# UNITED STATES PATENT AND TRADEMARK OFFICE

APPLICATION NO.	FILING DATE	FIRST NAMED INVENTOR	ATTORNEY DOCKET NO.	CONFIRMATION NO.
10/053,278	01/16/2002	Hyung-Jik Byun	9903-40	1314

# Office Action Summary

## DETAILED ACTION

FIG. 1

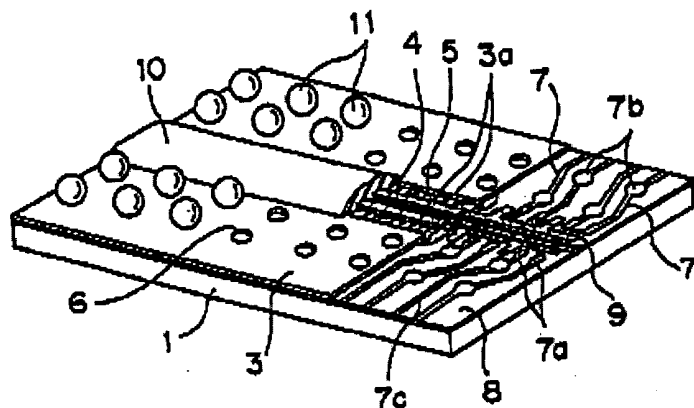
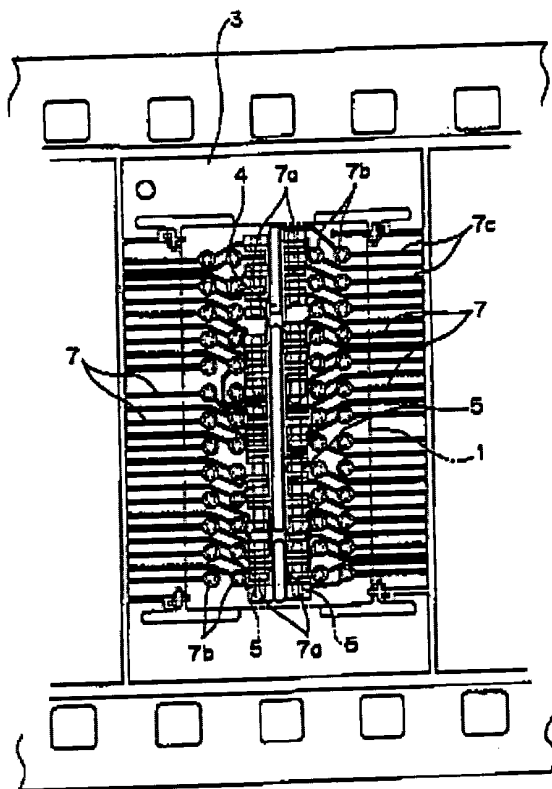
Claims 1-8, 12-13, 17, 19-20 and 22 are rejected under 35 U.S.C. 102(b) as being anticipated by Amagai (6,144,102). The intended use of the instantly claimed article is noted, however, the intended use does not patentably distinguish said claimed article over the prior art. Only the structure of the substrate and the semiconductor chip package have been given patentable weight. Thus, dummy pads and dummy patterns have been considered just pads and patterns, respectively. Dummy pads and dummy patterns have not been structurally limited over ordinary pads and traces. It is the Examiner's position that until electrical connections are formed to the pads all of the pads are dummy pads. In addition, it is inherent that the orientation of the pads (top/bottom) can be changed by flipping the components, thus the pads can be on the top or bottom of the component depending on the orientation.

Amagai et al. teaches an enhanced pad having one or more pads coupled to one or more patterns (Figures 1 and 3; and column 4, line 36-column 5, line 2); said enhanced pads are formed near an outer edge of said substrate (Figures 1 and 3; and column 5, lines 45-63) a solder ball formed on said ball pad (Figures 1 and 3; and column 5, lines 45-63); a substrate, a plurality of enhanced pads each enhanced pad having one or more pads coupled to one or more patterns, a semiconductor chip mounted on and electrically connected to the top surface of the substrate (Figures 1 and 3; and column 4, line 36-column 5, line 2); a molding resin for encapsulating said semiconductor chip (column 1, lines 36-50 and column 2, lines 22-47); ball pads are arranged in a substantially lattice shape on the bottom surface of the substrate (Figures 1 and 3); said enhanced pads comprise a second enhanced pad, and wherein the second enhanced pad comprises a ball pad, a pad, and a pattern connecting said ball pad to said dummy pad (Figures 1 and 3; and column 4, line 36-column 5, line 2); said enhanced pads comprise a third enhanced pad, and wherein the third enhanced pad comprises a plurality of pads and a pattern for connecting said pads to each other (Figures 1 and 3; and column 4, line 36-column 5, line 2); said solder balls are all approximately the same size (Figures 1 and 3; and column 4, line 36-column 5, line 2); arranging ball pads on a bottom surface of the substrate (Figures 1 and 3; and column 4, line 36-column 5, line 2); arranging a plurality of enhanced pads on the bottom surface of the substrate, said enhanced pads comprising at least one pad coupled to at least one pattern (Figures 1 and 3; and column 4, line 36-column 5, line 2); arranging said enhanced pads further comprises arranging said enhanced pads near sides of the

substrate; one or more of said enhanced pads comprise a plurality of patterns (Figures 1 and 3; and column 4, line 36-column 5, line 2).

**FIG. 4**

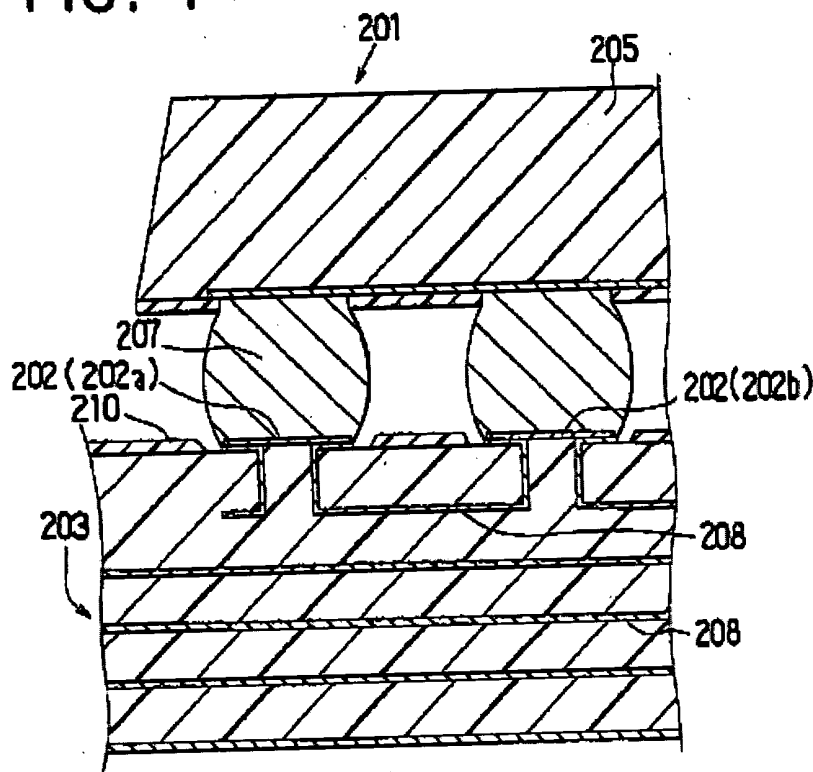
Claims 1-8, 12-14 and 17-22 are rejected under 35 U.S.C. 102(e) as being anticipated by Kondo et al. (6,303,878 B1). The intended use of the instantly claimed article is noted, however, the intended use does not patentably distinguish said claimed article over the prior art. Only the structure of the substrate and the semiconductor chip package have been given patentable weight. Thus, dummy pads and dummy patterns

Kondo et al. teaches an enhanced pad having one or more pads coupled to one or more patterns (Figure 4, specifically "202a, 202b and 208"; column 4, lines 27-32; and column 6, lines 52-64); said enhanced pads are formed near an outer edge of said substrate (Figure 5); a solder ball formed on said ball pad (abstract and Figures); a substrate, a plurality of enhanced pads each enhanced pad having one or more pads coupled to one or more patterns, a semiconductor chip mounted on and electrically connected to the top surface of the substrate (Figure 4, specifically "202a, 202b and 208"; column 4, lines 27-32; and column 6, lines 52-64); a molding resin for encapsulating said semiconductor chip (column 4, lines 9-18); ball pads are arranged in a substantially lattice shape on the bottom surface of the substrate (Figures 1 and 3); said enhanced pads comprise a second enhanced pad, and wherein the second enhanced pad comprises a ball pad, a pad, and a pattern connecting said ball pad to said dummy pad (Figure 2; Figure 4, specifically "202a, 202b and 208"; column 4, lines 27-32; and column 6, lines 52-64); said enhanced pads comprise a third enhanced pad, and wherein the third enhanced pad comprises a plurality of pads and a pattern for connecting said pads to each other (Figure 2; Figure 4, specifically "202a, 202b and

208"; column 4, lines 27-32; and column 6, lines 52-64); a board, said board comprising enhanced lands corresponding to said enhanced pads and ball lands corresponding to said ball pads, wherein said semiconductor chip package is mounted on said board (Figure 2; Figure 4, specifically "202a, 202b and 208"; column 4, lines 27-32; and column 6, lines 52-64); said solder balls are all approximately the same size (Figures); a majority of said dummy patterns are arranged parallel to a long side of said substrate (Figure 4, specifically "202a, 202b and 208"); arranging ball pads on a bottom surface of the substrate (Figure 2; Figure 4, specifically "202a, 202b and 208"; column 4, lines 27-32; and column 6, lines 52-64); arranging a plurality of enhanced pads on the bottom surface of the substrate, said enhanced pads comprising at least one pad coupled to at least one pattern (Figure 2; Figure 4, specifically "202a, 202b and 208"; column 4, lines 27-32; and column 6, lines 52-64); arranging said enhanced pads further comprises arranging said enhanced pads near sides of the substrate; one or more of said enhanced pads comprise a plurality of patterns (figure 2; Figure 4, specifically "202a, 202b and 208"; column 4, lines 27-32; and column 6, lines 52-64).

FIG. 7

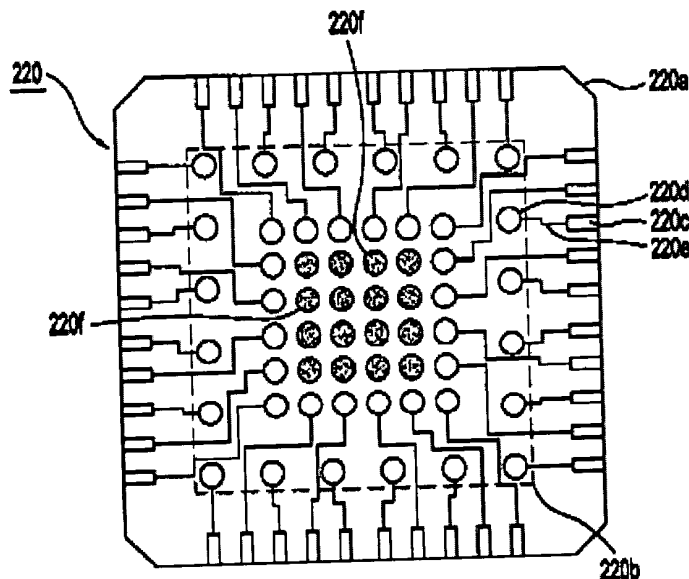
Claims 1-8, 12-14 and 17-22 are rejected under 35 U.S.C. 102(e) as being anticipated by Hsu et al. (6,242,815 B1). The intended use of the instantly claimed article is noted, however, the intended use does not patentably distinguish said claimed article over the prior art. Only the structure of the substrate and the semiconductor chip package have been given patentable weight. Thus, dummy pads and dummy patterns have been considered just pads and patterns, respectively. Dummy pads and dummy patterns have not been structurally limited over ordinary pads and traces. It is the Examiner's position that until electrical connections are formed to the pads all of the pads are dummy pads. In addition, it is inherent that the orientation of the pads

Hsu et al. teaches an enhanced pad having one or more pads coupled to one or more patterns (Figure 7, specifically "220c, 220d, 220e"; column 3, lines 14-column 4, line 44); said enhanced pads are formed near an outer edge of said substrate (Figure 5); a solder ball formed on said ball pad (abstract and Figures); a substrate, a plurality of enhanced pads each enhanced pad having one or more pads coupled to one or more patterns, a semiconductor chip mounted on and electrically connected to the top surface of the substrate (Figure 7, specifically "220c, 220d, 220e"; column 3, lines 14-column 4, line 44); a molding resin for encapsulating said semiconductor chip (column 1, lines 12-33 and column 3, lines 15-20); ball pads are arranged in a substantially lattice shape on the bottom surface of the substrate (Figure 7); said enhanced pads comprise a second enhanced pad, and wherein the second enhanced pad comprises a ball pad, a pad, and a pattern connecting said ball pad to said dummy pad (Figure 7, specifically "220c, 220d, 220e"; column 3, lines 14-column 4, line 44); said enhanced pads comprise a third enhanced pad, and wherein the third enhanced pad comprises a plurality of pads and a pattern for connecting said pads to each other (Figure 7, specifically "220c, 220d, 220e"; column 3, lines 14-column 4, line 44); a board, said board comprising enhanced lands corresponding to said enhanced pads and ball lands corresponding to said ball pads, wherein said semiconductor chip package is mounted on said board (Figure 7, specifically "220c, 220d, 220e"; column 3, lines 14-column 4, line 44); said solder balls are all approximately the same size (Figures); a majority of said dummy patterns are

arranged parallel to a long side of said substrate (Figure 7, specifically "220c, 220d, 220e"; column 3, lines 14-column 4, line 44); arranging ball pads on a bottom surface of the substrate (Figure 7, specifically "220c, 220d, 220e"; column 3, lines 14-column 4, line 44); arranging a plurality of enhanced pads on the bottom surface of the substrate, said enhanced pads comprising at least one pad coupled to at least one pattern (Figure 7, specifically "220c, 220d, 220e"; column 3, lines 14-column 4, line 44); arranging said enhanced pads further comprises arranging said enhanced pads near sides of the substrate; one or more of said enhanced pads comprise a plurality of patterns (Figure 7, specifically "220c, 220d, 220e"; column 3, lines 14-column 4, line 44).
